**PRAIRIE ISLAND NUCLEAR GENERATING PLANT**  
Docket Nos. 50-282 License Nos. DPR-42  
50-306 DPR-60

Request for Relief No. 11 for the Unit 1 3rd 10-year Interval Inservice Inspection Program

Attachment: ISI Relief Request No. 11 (Rev. 0), Limited Examination (37 pages)

ISI Relief Request No. 11 (Rev. 0)

Report No.: 2001U004

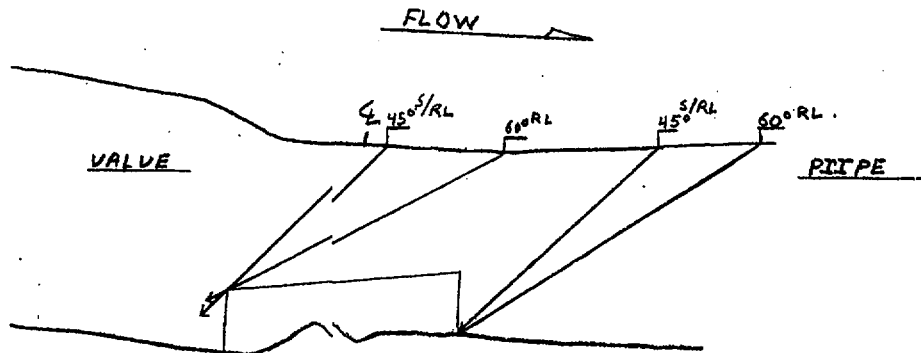
**Single side access due to valve to pipe configuration.**

Report # No.: 2001U039

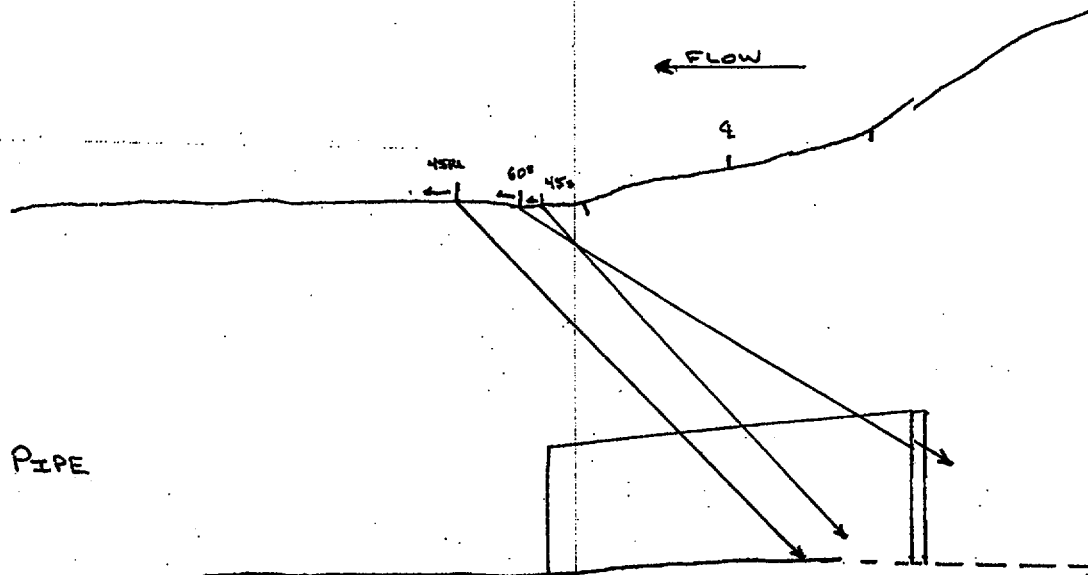
Reactor Coolant, Weld W-1, (RC pump to Pipe), Iso/Dwg ISI-12C, Summary No. 300514, 38.85% Coverage volumetric examination. Single side examination only due to pump to pipe configuration

Report No.: 2001U010

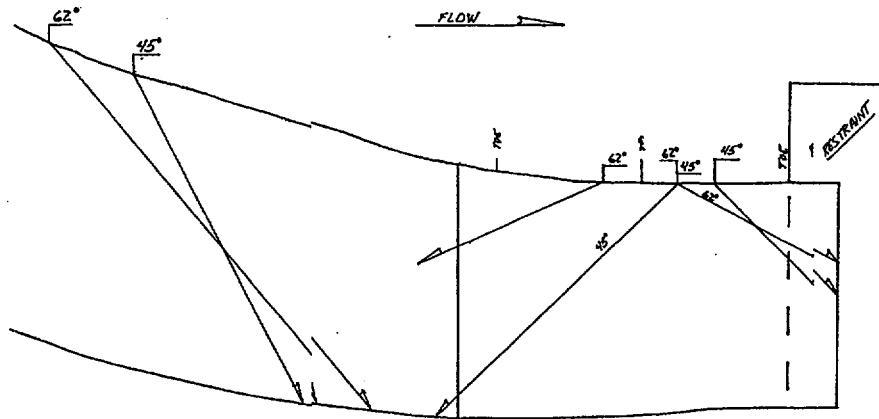
#12 Steam Generator, Weld W-E, (Shell –Transition), Iso/Dwg ISI-43B, Summary No. 301070, 70.88% Coverage volumetric examination. Restraint ring prohibits scanning from downstream side of weld.

Site/Unit: <u>NSP / P11</u>	Procedure: <u>ISI-UT-16</u>	Report No.: <u>2001U029</u>
Summary No.: <u>303054</u>	F Procedure Revision/FC: <u>13 /</u>	P Page: <u>6</u> of <u>6</u>
Examination For: <u>ISI</u>	Work Order No.: <u>0010296</u>

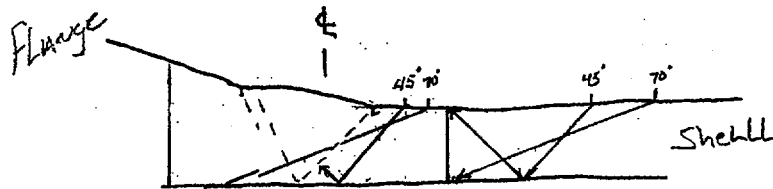
RHR Heat Exchanger #12, Weld W-2 , (Shell –Flange) Iso/Dwg ISI-93B, Summary No. 303054, 27.26% Coverage volumetric examination. Weld geometry limits scans.

Site/Unit:	NSP / P11	Procedure:	ISI-MT-1	Report No.:	2001M011
Summary No.:	301122	Procedure Revision/FC:	11 /	Page:	2 of 3
Examination For:	ISI	Work Order No.:	0010296

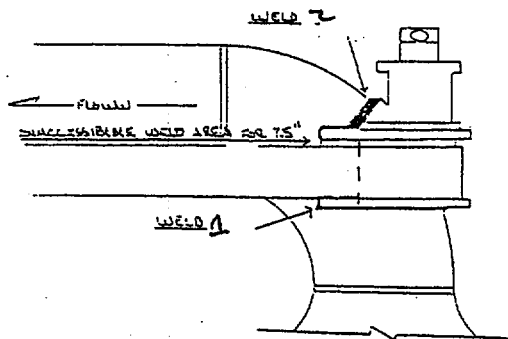
Examination limited to 188" weld length out of 2270" total weld length due to configuration of restraint.

Site/Unit:	<u>NSP / P11</u>	Procedure:	<u>ISI-MT-1</u>	Report No.:	<u>2001M010</u>
Summary No.:	<u>301132</u>	F Procedure Revision/FC:	<u>11 /</u>	F Page:	<u>2</u> of <u>3</u>
Examination For:	<u>ISI</u>	Work Order No.:	<u>0010296</u>

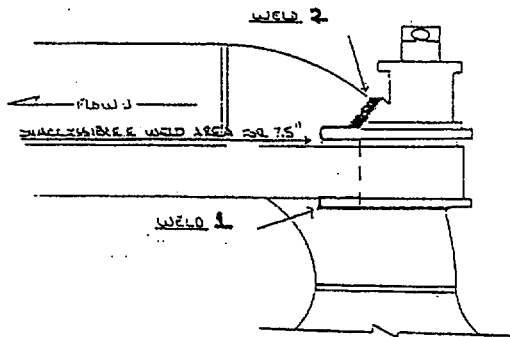
Examination limited to 76" weld length out of 91" total weld length due to configuration of restraint.

Site/Unit:	<u>NSP / PI1</u>	Procedure:	<u>ISI-MT-1</u>	Report # No.:	<u>2001M013</u>
Summary No.:	<u>301134</u>	P Procedure Revision/FC:	<u>11 /</u>	P Page:	<u>2</u> of <u>3</u>
Examination For:	<u>ISI</u>	Work Order No.:	<u>0010296</u>

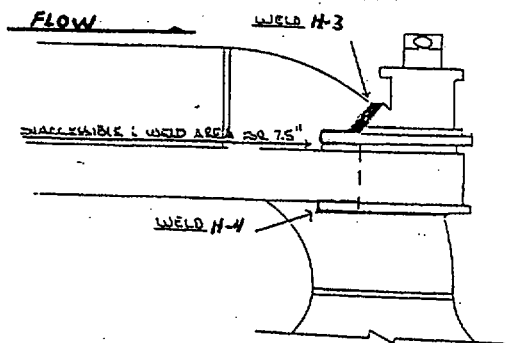
Examination limited to 188" weld length out of 277'0" total weld length due to configuration of restraint.

Report No.: 2001M012

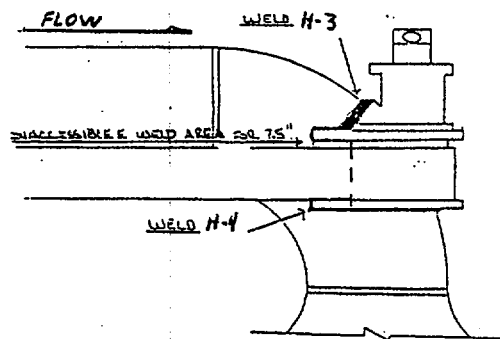
Examination limited to 76" weld length out of 91" total weld length due to configuration of restraint.

Site/Unit:	<u>NSP / PI1</u>	Procedure:	<u>ISI-MT-1</u>	Report No.:	<u>2001M019</u>
Summary No.:	<u>301177</u>	Procedure Revision/FC:	<u>11 /</u>	Page:	<u>4</u> of <u>4</u>
Examination For:	<u>ISI</u>	Work Order No.:	<u>0010296</u>

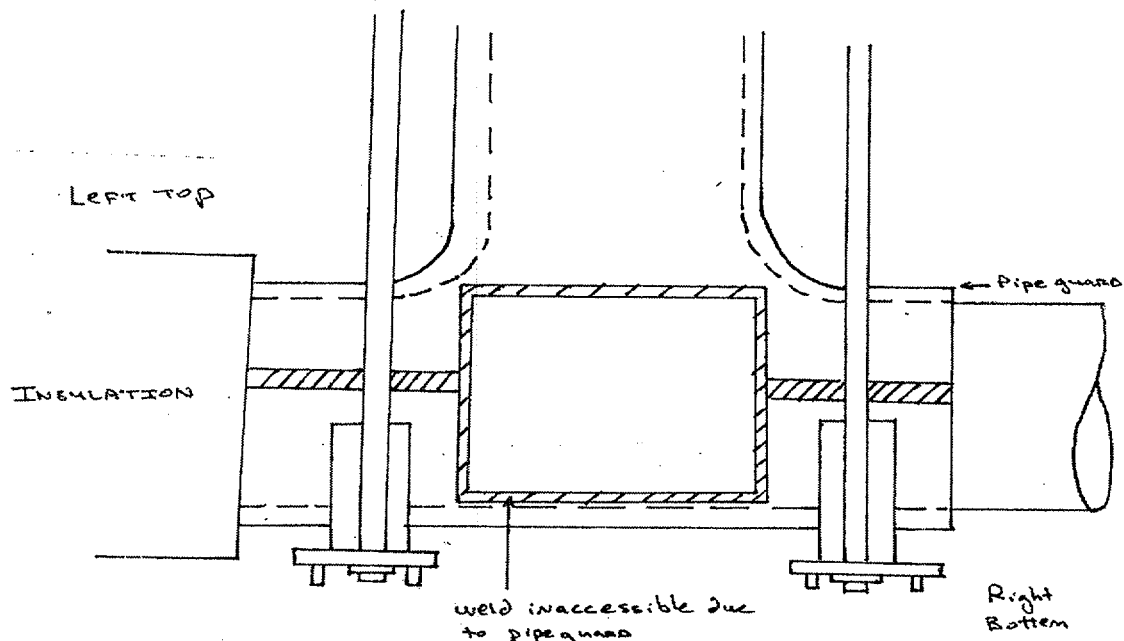
In Guard Pipe - 0% Coverage.

Report No.: 2001M008

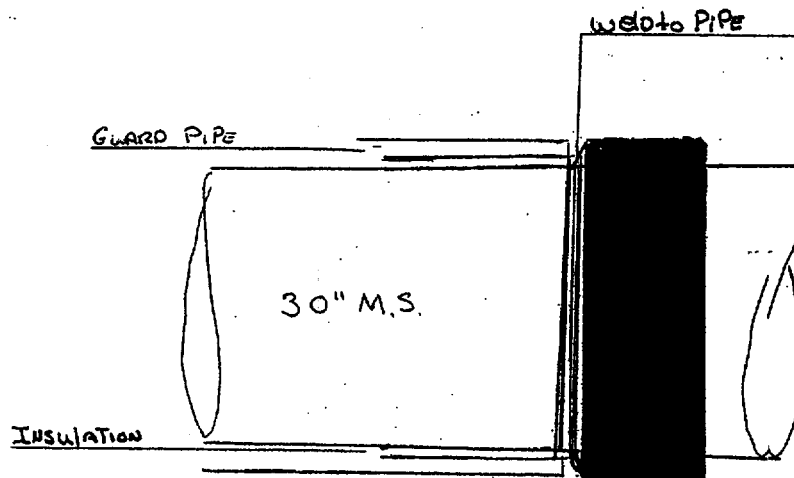
Comments: Weld to pipe obstructed by g guard pipe and insulation.

Site/Unit:	NSP / P11	Procedure:	ISI-MT-1	Report No.:	2001M017
Summary No.:	301596	Procedure Revision/FC:	11 /	I Page:	2 of 2
Examination For:	ISI	Work Order No.:	0010296

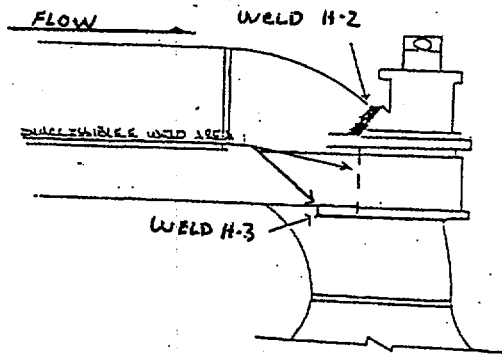
Examination limited to 188" weld length out of 2270" total weld length due to configuration of restraints.

Site/Unit:	<u>NSP / PI1</u>	Procedure:	<u>ISI-MT-1</u>	Report No.:	<u>2001M028</u>
Summary No.:	<u>302066</u>	F Procedure Revision/FC:	<u>11 /</u>	F Page:	<u>2</u> of <u>3</u>
Examination For:	<u>ISI</u>	Work Order No.:	<u>0010296</u>

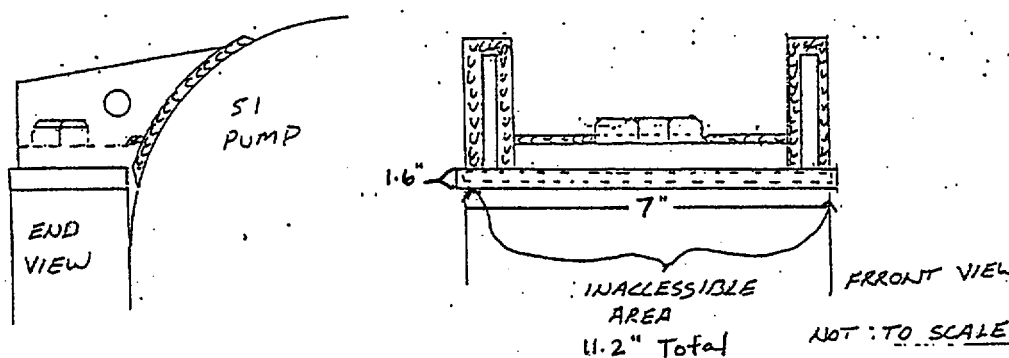
Configuration prohibits examining weld at base c of support.

Site/Unit:	NSP / PI1	Procedure:	ISI-MT-1	Report No.:	2001M027
Summary No.:	302070	F Procedure Revision/FC:	11 /	PPage:	2 of 3
Examination For:	ISI	Work Order No.:	0010296

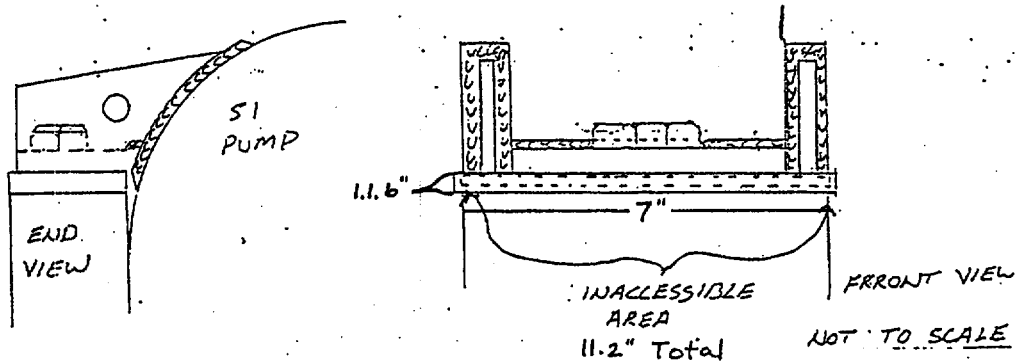
Configuration prohibits examining weld at base of support.

Site/Unit:	<u>NSP / PI1</u>	Procedure:	<u>ISI-MT-1</u>	Report No.:	<u>2001M026</u>
Summary No.:	<u>302074</u>	PProcedure Revision/FC:	<u>11 /</u>	PPage:	<u>2</u> of <u>3</u>
Examination For:	<u>ISI</u>	Work Order No.:	<u>0010296</u>

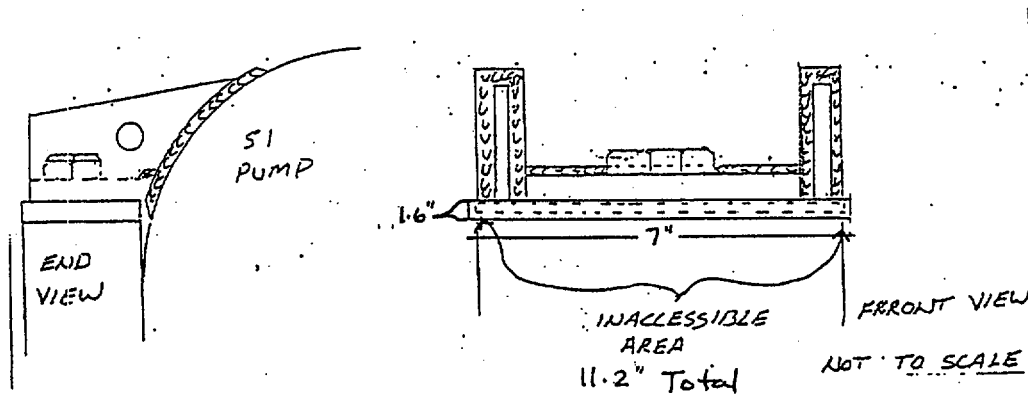
Configuration prohibits examining weld at base o of support.

Site/Unit:	NSP / PI1	Procedure:	ISI-MT-1	Report No.:	2001M025
Summary No.:	302078	F Procedure Revision/FC:	11 /	F Page:	2 of 3
Examination For:	ISI	Work Order No.:	0010296

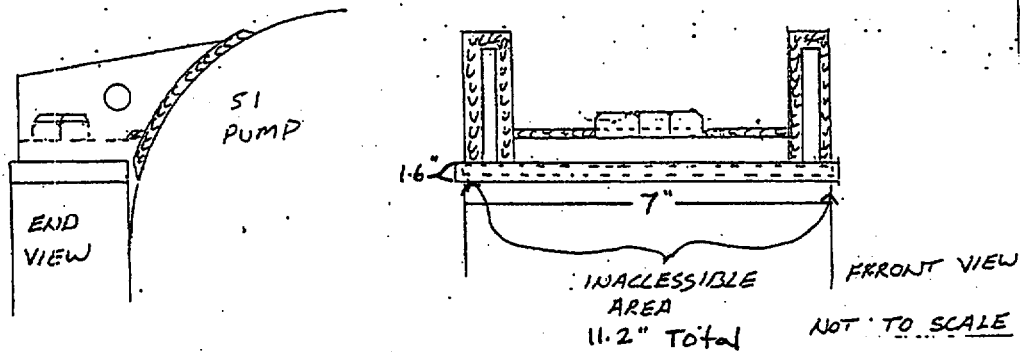
Configuration prohibits examining weld at base of support.

Site/Unit:	NSP / PI1	Procedure:	ISI-MT-1	Report No.:	2001M030
Summary No.:	302082	F Procedure Revision/FC:	11 /	F Page:	2 of 3
Examination For:	ISI	Work Order No.:	0010296

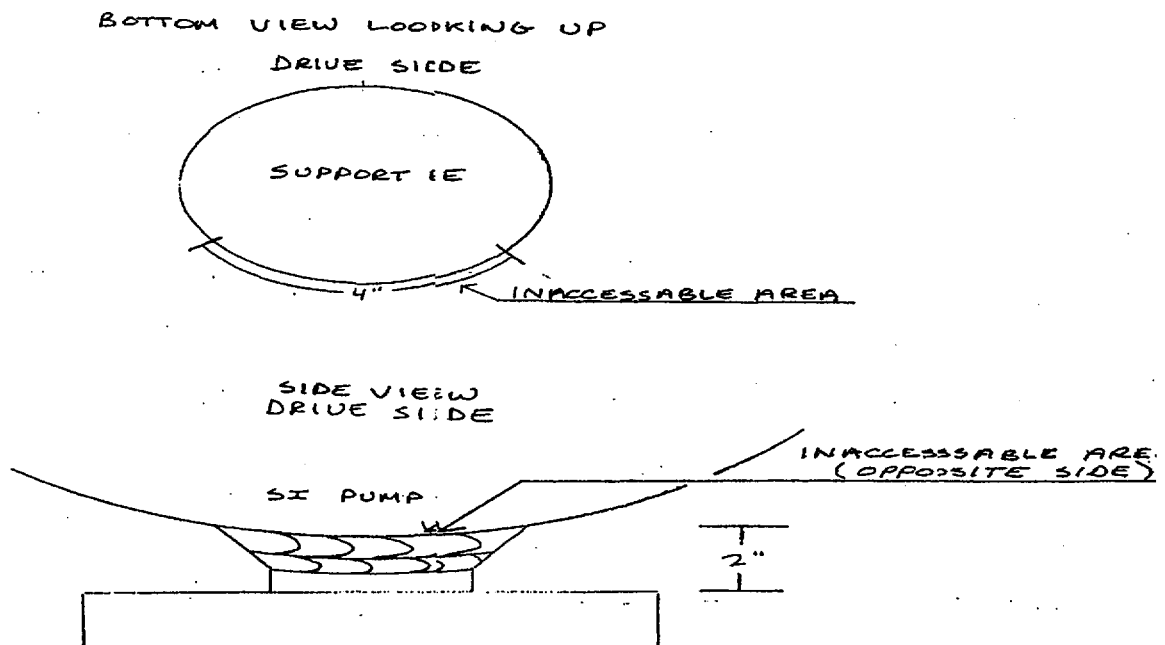
Configuration prohibits examining weld at inside e of support.

Site/Unit: <u>NSP / PI1</u>	Procedure: <u>ISI-MT-1</u>	Report No.: <u>2001M024</u>
Summary No.: <u>302086</u>	Procedure Revision/FC: <u>11 /</u>	Page: <u>2</u> of <u>3</u>
Examination For: <u>ISI</u>	Work Order No.: <u>0010296</u>

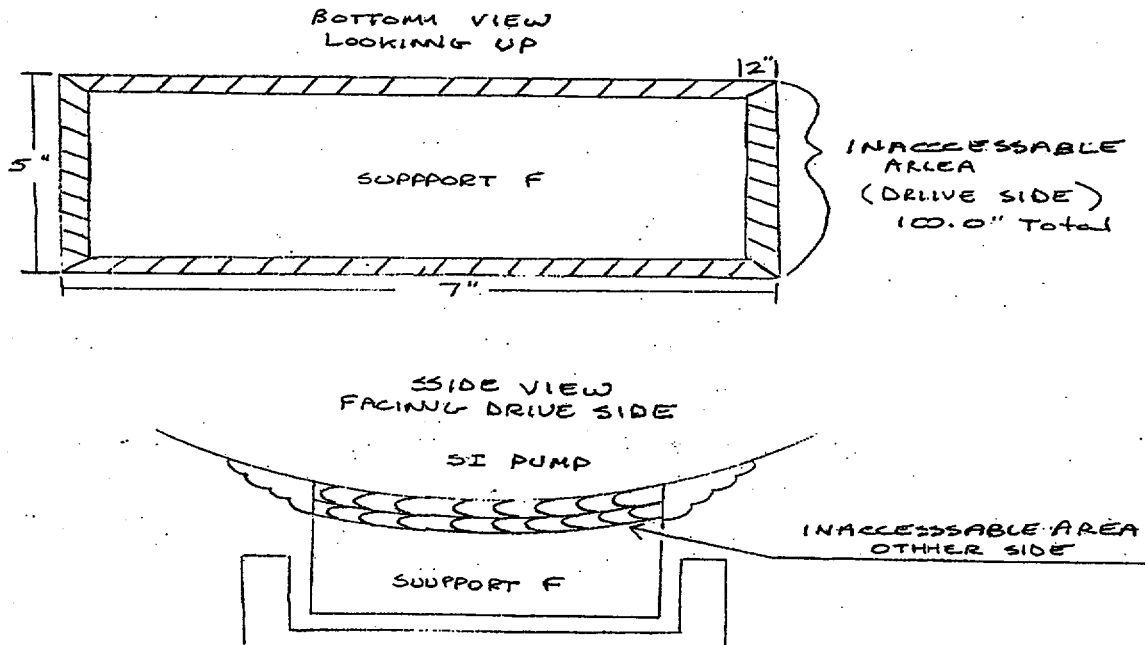
Configuration prohibits examining weld at inside of support (drive side).

Site/Unit:	<u>NSP / PI1</u>	Procedure:	<u>ISI-PT-1</u>	Report No.:	<u>2001P056</u>
Summary No.:	<u>303052</u>	P Procedure Revision/FC:	<u>13 /</u>	P Page:	<u>2</u> of <u>3</u>
Examination For:	<u>ISI</u>	Work Order No.:	<u>0010296</u>

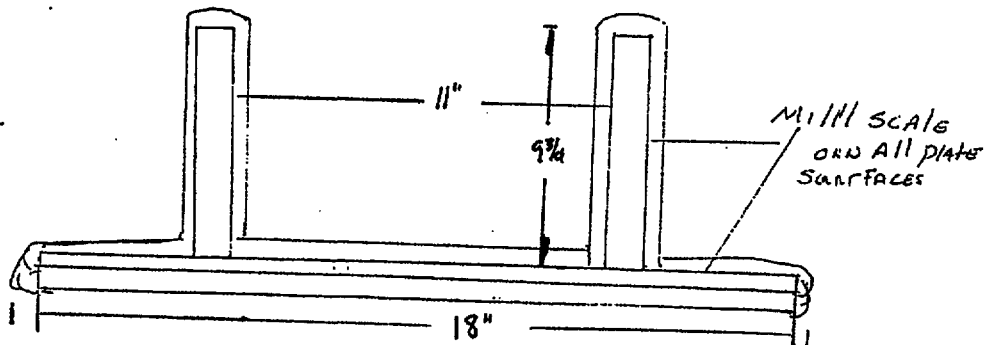
Mill scale located on support base metal. Mill scale is tightly adhering and could not be removed by wire wheel or flapping. Bottom of support is inaccessible for removal work.

Site/Unit:	<u>NSP / PI1</u>	Procedure:	<u>ISI-UT-16A</u>	Report No.:	<u>2001U034</u>
Summary No.:	<u>305137</u>	Procedure Revision/FC:	<u>0 /</u>	Page:	<u>2</u> of <u>3</u>
Examination For:	<u>ISI</u>	Work Order No.:	<u>0010296</u>

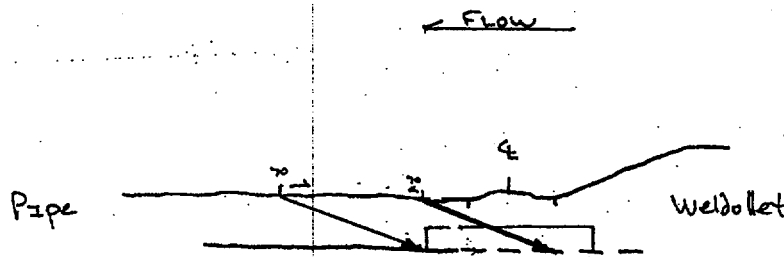
One sided examination due to weld crown and configuration.

Site/Unit:	<u>NSP / PI1</u>	Procedure:	<u>ISI-UT-16A</u>	Report # No.:	<u>2001U013</u>
Summary No.:	<u>301874</u>	PProcedure Revision/FC:	<u>0 /</u>	PPage:	<u>2</u> of <u>3</u>
Examination For:	<u>ISI</u>	Work Order No.:	<u>0010296</u>

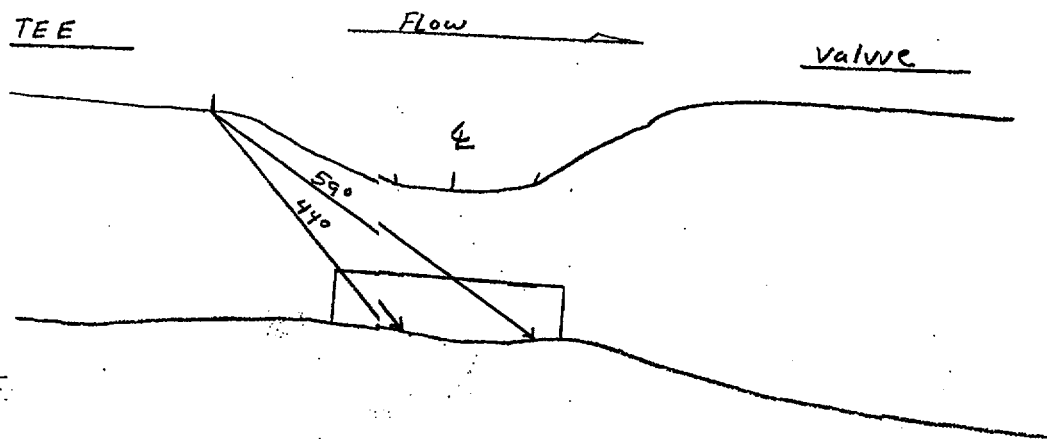
RHR Pump "B" Discharge , Weld W-18 (Tee-Valve), Iso/Dwg ISI-89B ,Summary No. 301874, 49.2% Coverage volumetric examination. Single side examination due to tee to valve configuration.

Report No.: 2001M016  
Page: 2 of 3

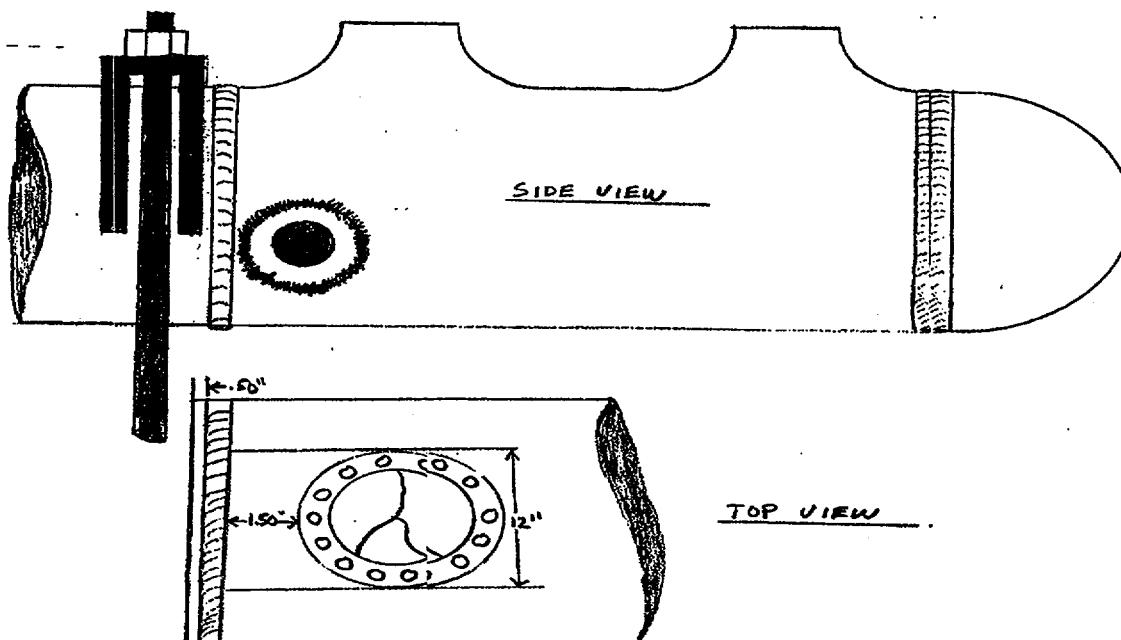
Main Steam "B", Weld W-9LSD2U (Tee –Pipe), Iso/Dwg ISI-68C, Summary No. 301619, 87.6% Coverage surface examination. Limited due to nozzle configuration.
